UNITED STATES PATENT AND TRADEMARK OFFICE

APPLICATION NO.	FILING DATE	FIRST NAMED INVENTOR	ATTORNEY DOCKET NO.	CONFIRMATION NO.
10/788,771	02/27/2004	Pieter G. Wybro	MOD013/145573	8450

Office Action Summary

DETAILED ACTION

Fig. 10

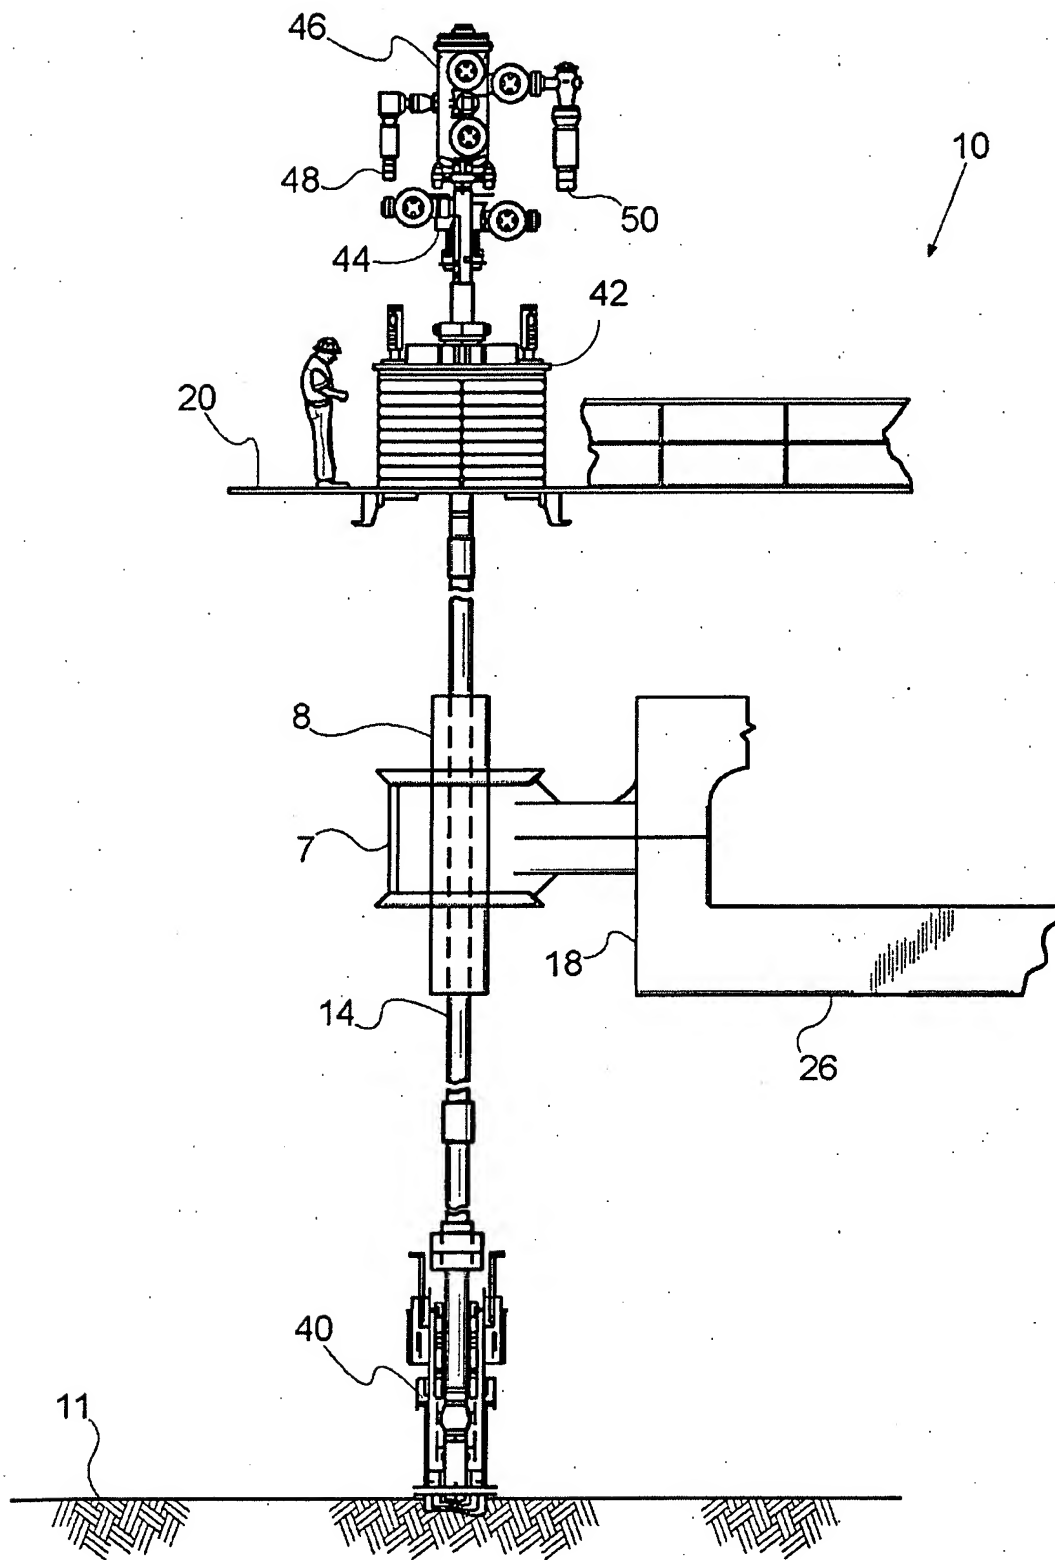
1. A request for continued examination under 37 CFR 1.114, including the fee set forth in 37 CFR 1.17(e), was filed in this application after final rejection. Since this application is eligible for continued examination under 37 CFR 1.114, and the fee set forth in 37 CFR 1.17(e) has been timely paid, the finality of the previous Office action has been withdrawn pursuant to 37 CFR 1.114. Applicant's submission filed on 10/30/2007 has been entered.
2. The drawings are objected to under 37 CFR 1.83(a). The drawings must show every feature of the invention specified in the claims. Therefore, the passive spring riser tensioner must be shown or the feature(s) canceled from the claim(s). No new matter should be entered.

3. The proposed replacement sheet of drawings filed 10/30/2007 has not been approved by the examiner, as such is considered to be New Matter. There is no basis in the disclosure as originally filed for the element in the figure to now be called the passive riser tensioner.

Not Approved Ees 11/24/07

Corrected drawing sheets in compliance with 37 CFR 1.121(d) are required in reply to the Office action to avoid abandonment of the application. Any amended replacement drawing sheet should include all of the figures appearing on the immediate prior version of the sheet, even if only one figure is being amended. The figure or figure number of an amended drawing should not be labeled as "amended." If a drawing figure is to be canceled, the appropriate figure must be removed from the replacement sheet, and where necessary, the remaining figures must be renumbered and appropriate changes made to the brief description of the several views of the drawings for consistency. Additional replacement sheets may be necessary to show the renumbering of the remaining figures. Each drawing sheet submitted after the filing date of an application must be labeled in the top margin as either "Replacement Sheet" or "New
